Attention:	Brian Richardson	Date:	12/8/2014
Company:	C.C.S. Constructors	Job Name:	Stowe BRF 0235(11)
Address:	138 Munson Ave	Job Number:	#15163
City, St, Zip:	Morrisville, VT 05661	Regarding:	Abutment, Wing Wall, and Retaining Wall Submittal #1
Ph: / Fax:	802-888-7701

Stowe BRF 0235(II)

Vermont Agency of Transportation
RECEIVED
Abutment_WingWall_RetainingWall Submittal 1 120814_Resubmit 12.22.14.pdf

Bearing plate for tension ducts.

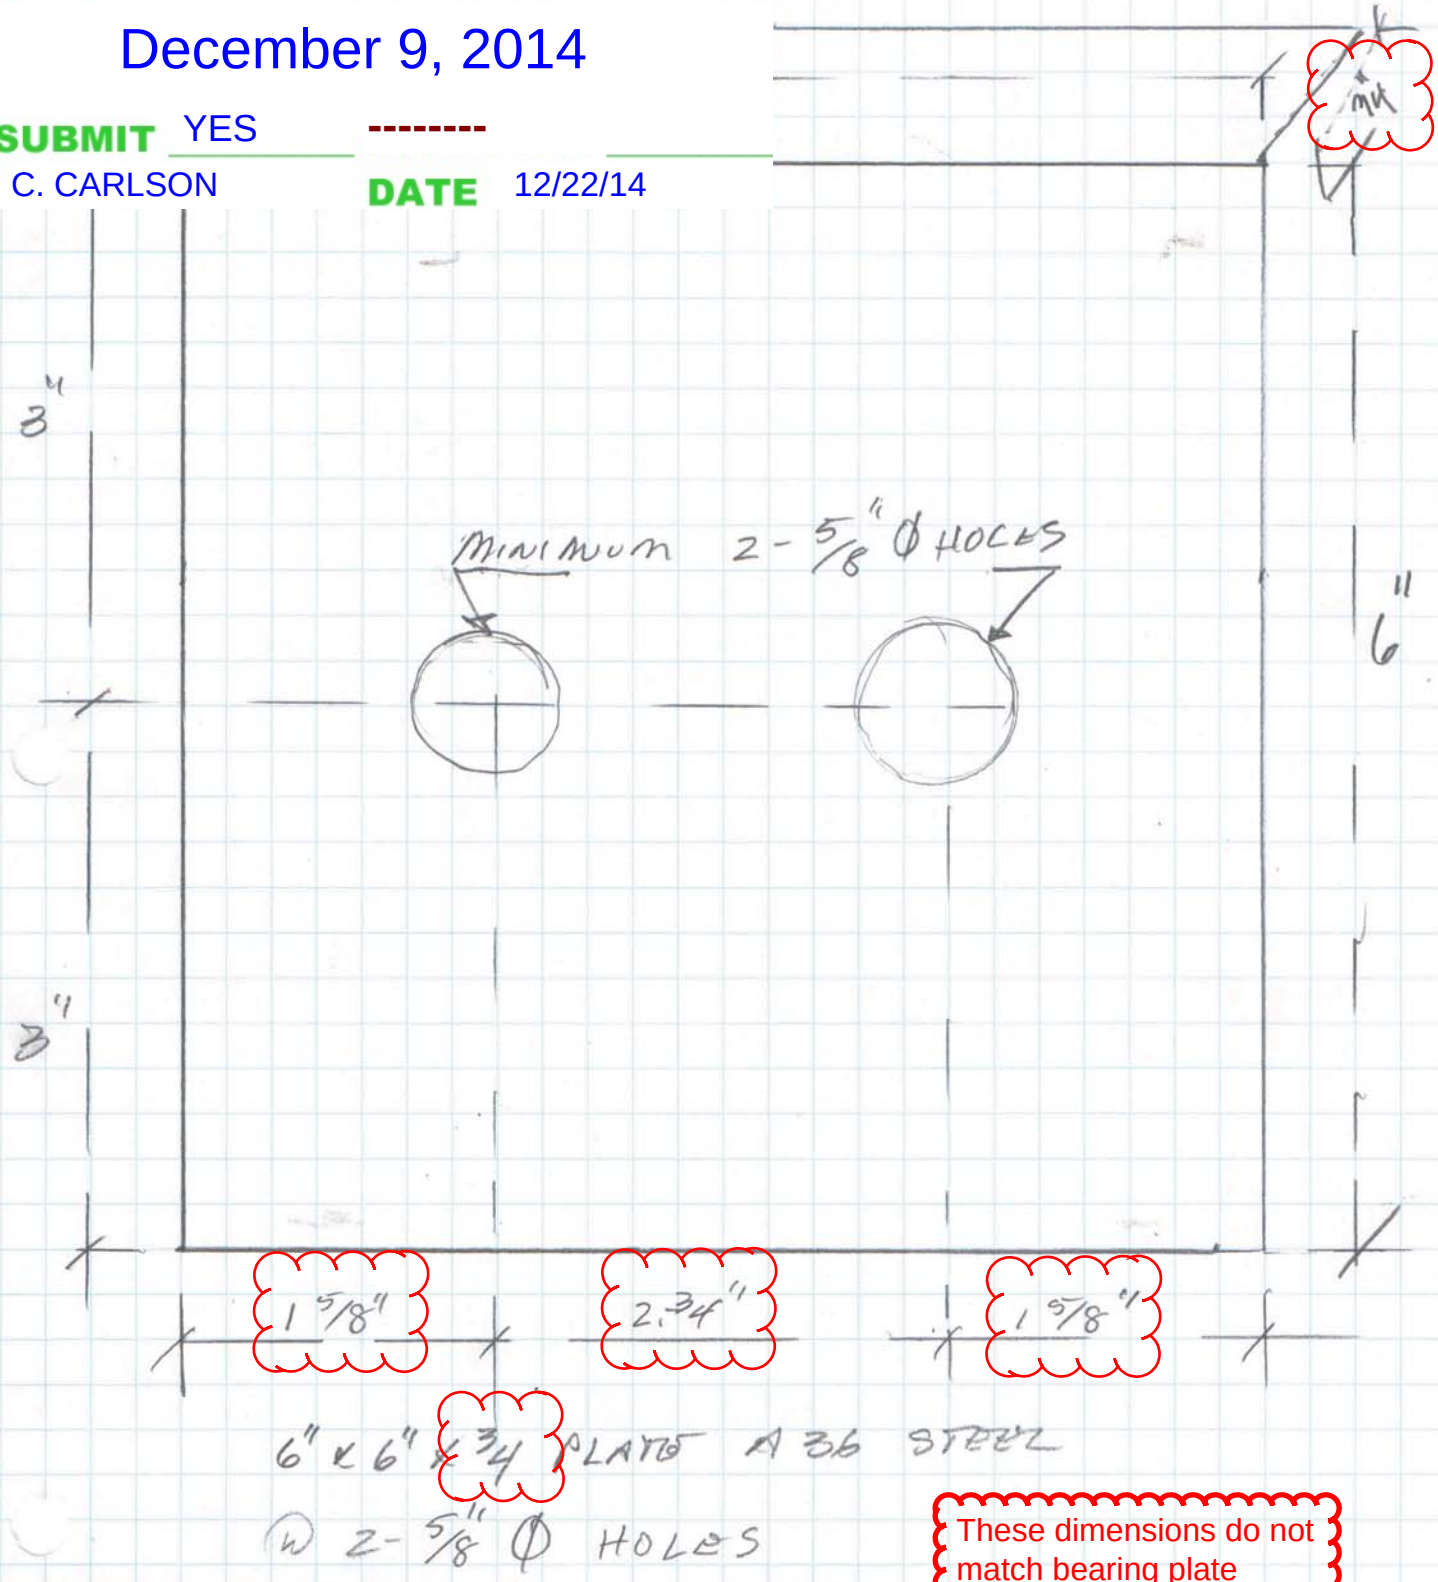
These dimensions do not match bearing plate details on shop drawing 8 of 11

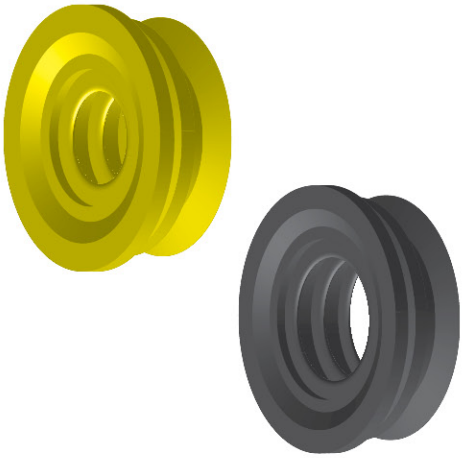
Why are these for #9 and #11 bars?
Should be for #5 and #7 bars.

Abutment Lifting Detail

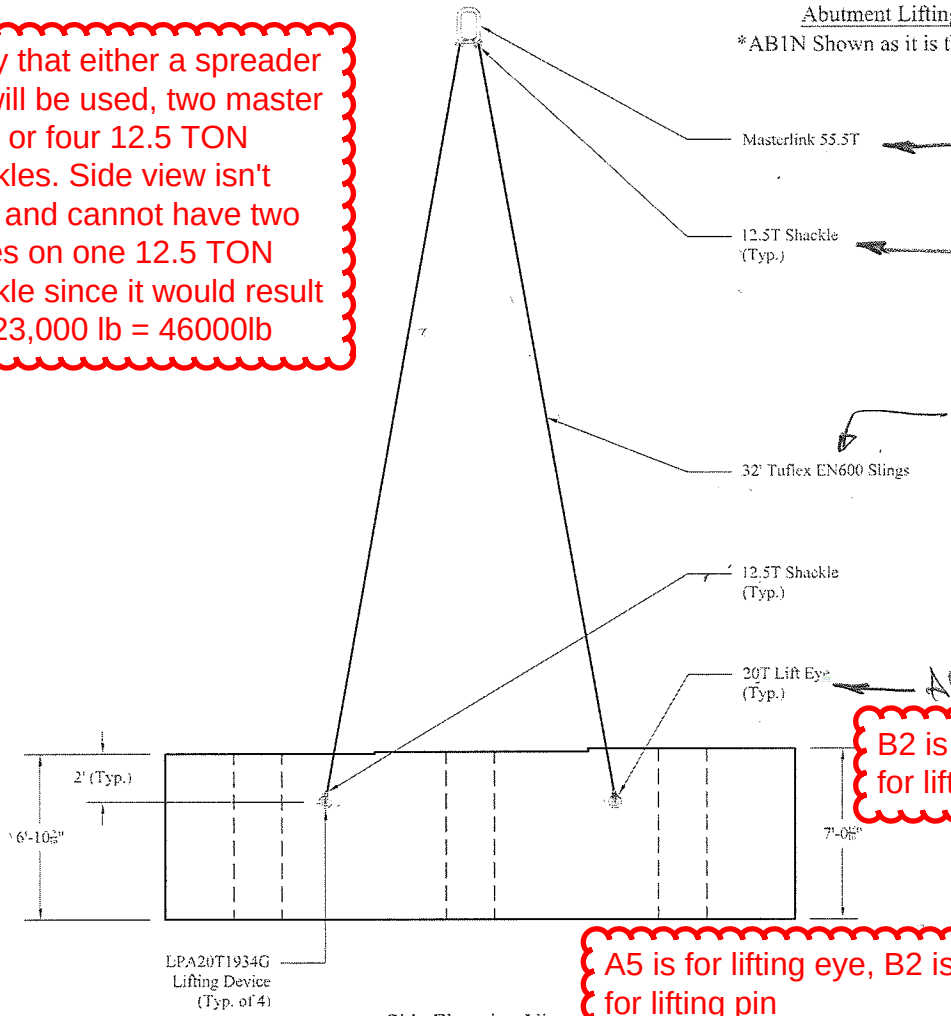
Verify that either a spreader bar will be used, two master links, or four 12.5 TON shackles. Side view isn't clear and cannot have two cables on one 12.5 TON shackle since it would result in 2*23,000 lb = 46000lb
